# HAYES STRUCTURAL

**Re:** 24-FRM-051  
Structural Analysis  
50 Alban Row  
Fuquay-Varina, NC 27526

At your request, the plans were reviewed for the above referenced single family residence renovation under construction to address two framing concerns noted by the inspector.

## K-SHCR-19

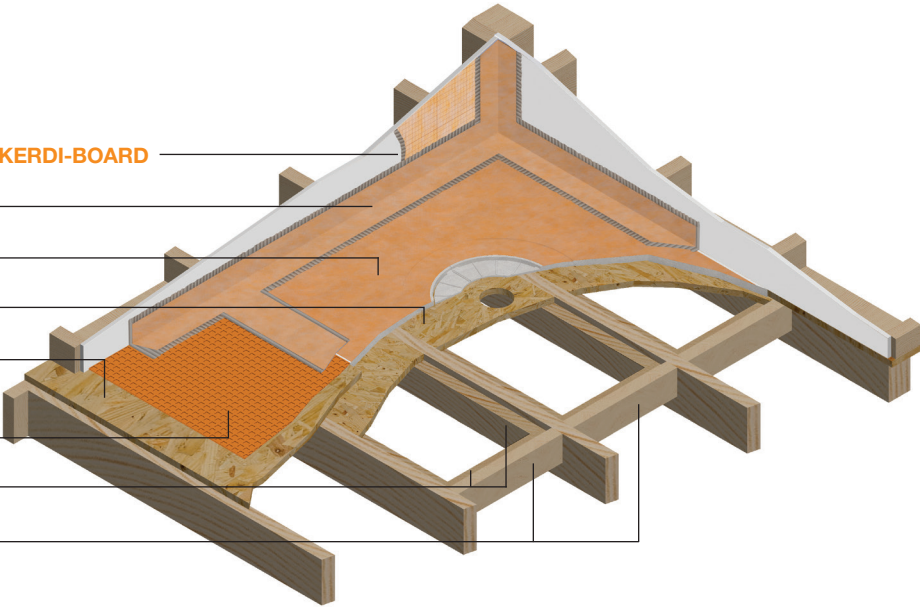
1. You indicated the plan specified double rafter above the wall between the playroom and bedroom was not installed. You also indicated the plan specified knee wall on top of the noted wall was not installed.
2. You indicated a Schluter-Shower System will be installed to create a recessed curbless shower in the upstairs ADA bathroom in lieu of framing out the shower with flush beams and installing 2x8 floor joists beneath the shower per plan.

1. Review of the plans revealed the wall between the playroom and bedroom to be a shear wall, requiring bracing at the top. The knee wall is to be framed on top of the noted wall per plan. In lieu of the double rafter, 2x8 blocking spaced 16" o.c. is to be installed between the adjacent rafters. Blocking is to be fastened to the adjacent rafter at each end with (2) 16d nails and to the double top plates of the knee wall with (3) 8d toe nails. See detail 1 on sheet SP2.0 and note D on sheet S4 for additional information.
2. The plan specified flush beams framing out the shower and 2x8 floor joists are not required. The Schluter-Shower System is to be installed per the attached detail.
